Class Probe Optimization

PSE Usage Model

Long Class Event Generates Heat

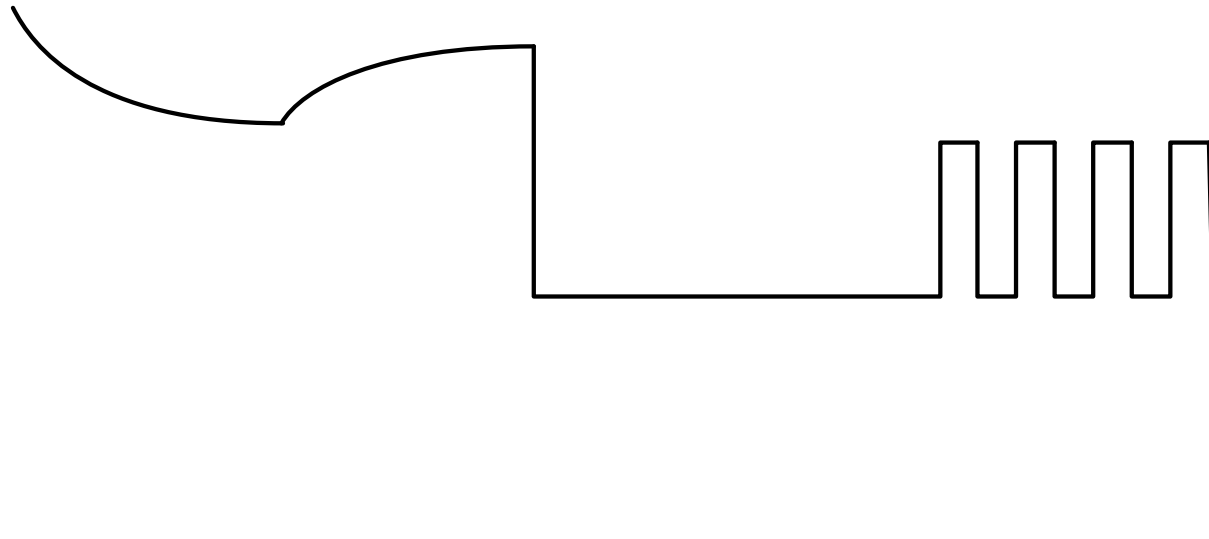
- Assume Long 1st class event are 96ms
- Assume subsequent class events are 3*12ms=36ms
- Total Class Energy = 54V * 40mA * 132ms = 285 mJoules

Class Probe Minimizes Heat

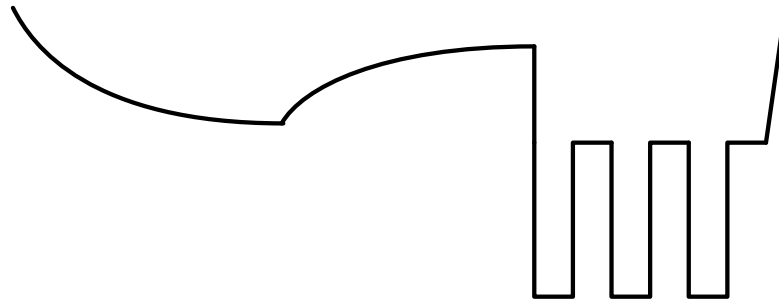
- Three class probes required to determine PD Requested Class
- Assume three class events are $3 * 12\text{ms} = 36\text{ms}$
- Total Class Energy = $54\text{V} * 40\text{mA} * 36\text{ms} = 78 \text{ mJoules}$

**73% Reduction in
Power Consumption**

Recommendation

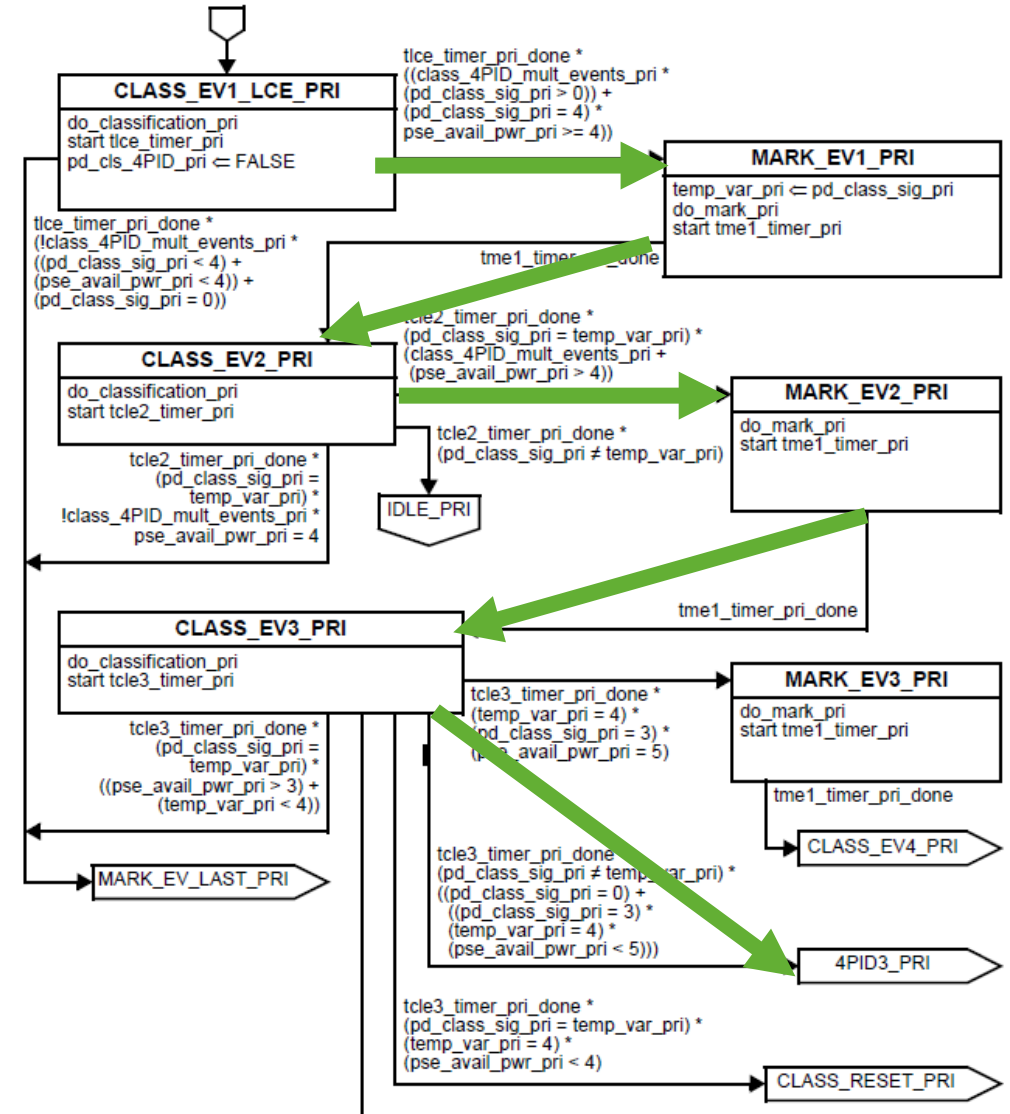
- Implement do_class_probe for single and dual-signature PSE state machines
 - Currently only implemented for single-signature state machine
 - Dual-signature “do class probe” equivalent is implemented explicitly
 - Does not allow for short 1st Class event
- Allow single and dual-signature state machines to return to IDLE after do_class_probe completion

- Replicate CLASSIFICATION pre-state and CLASS_PROBE in primary and secondary state machines
- Allow exit to IDLE after CLASS_PROBE completion
- No changes to downstream logic
